CITY OF ST. HELENS PLANNING DEPARTMENT

MEMORANDUM

TO: Planning Commission acting as the Historic Landmarks Commission
FROM: Jennifer Dimsho, AICP, Associate Planner
RE: 71 Cowlitz Street (The Klondike Tavern) Architectural Review
DATE: July 27, 2023

01 PHASE 2, 1ST FLOOR PLAN
SCALE: 1/4"=1'-0"

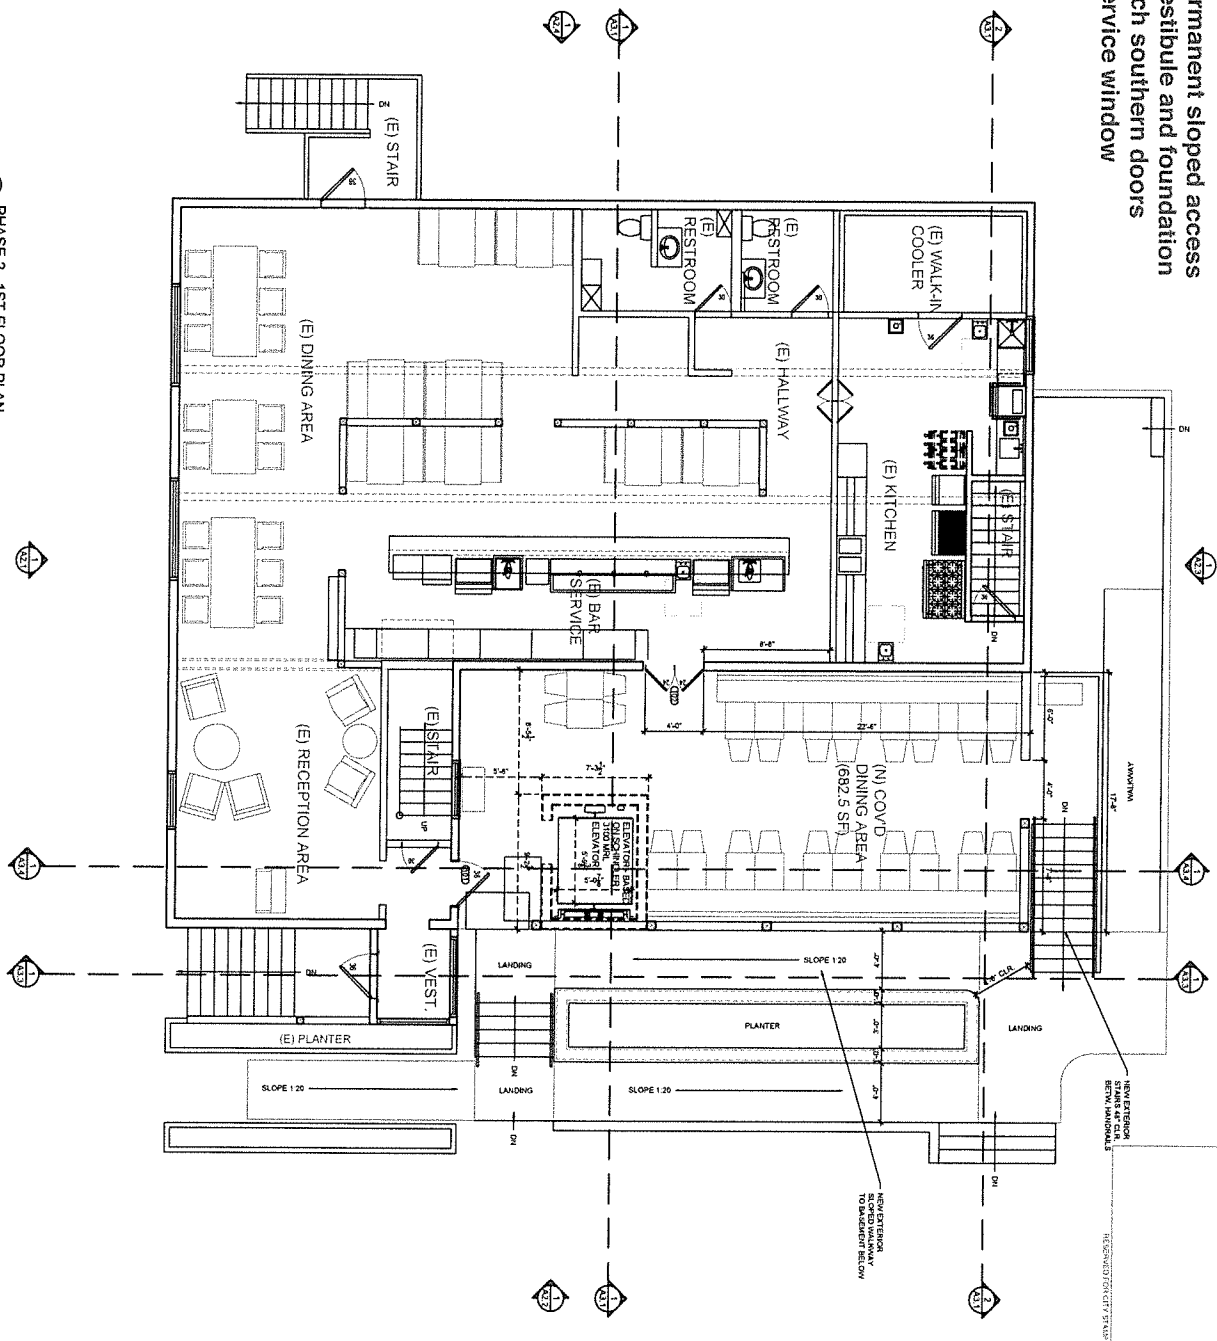
- Currently Proposed Layout:
- Replacing ADA lift with permanent sloped access
 - Building future elevator vestibule and foundation
 - Adding basement and porch southern doors
 - Adding small basement service window

⑦ SOUTH ELEVATION
SCALE 1/4"=1'-0"

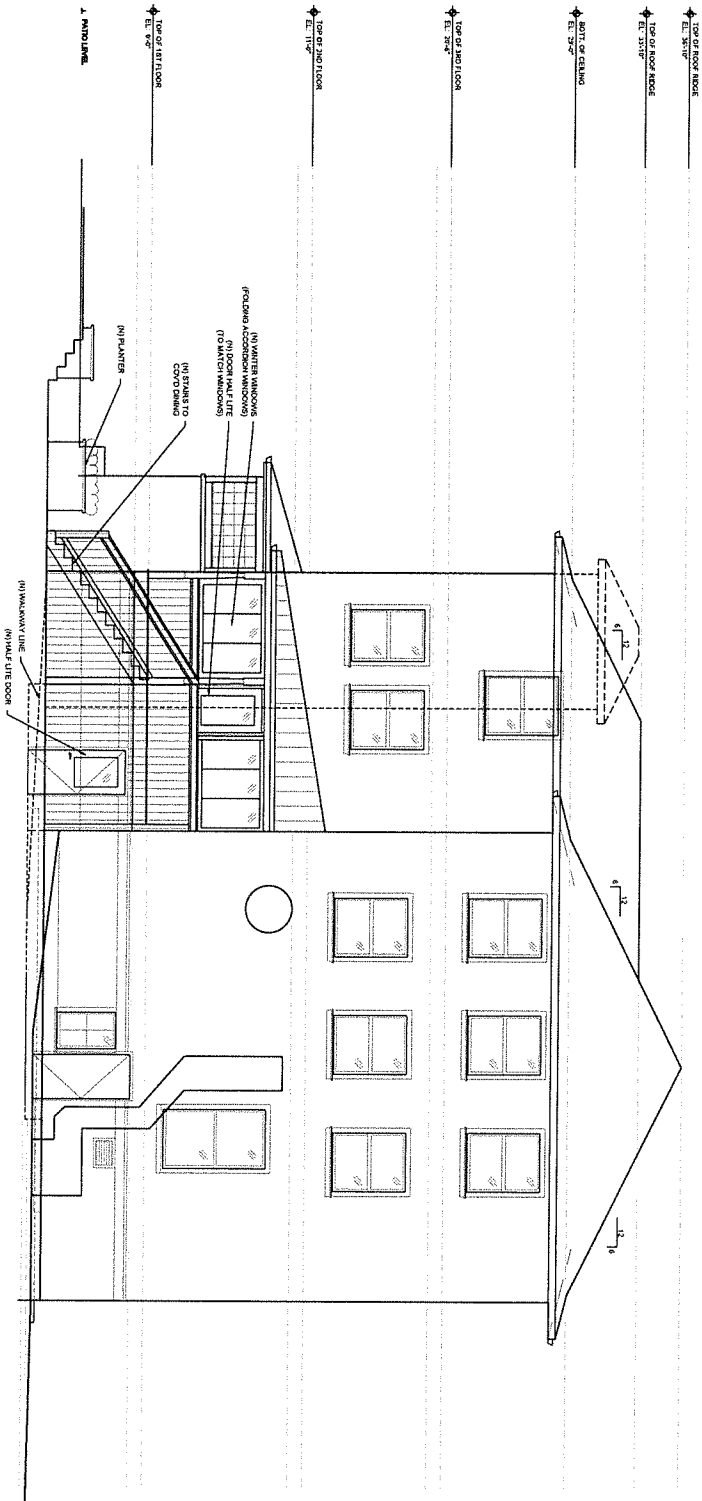
- New permanent ADA slope down with retaining walls/planters
- New basement and porch southern access doors
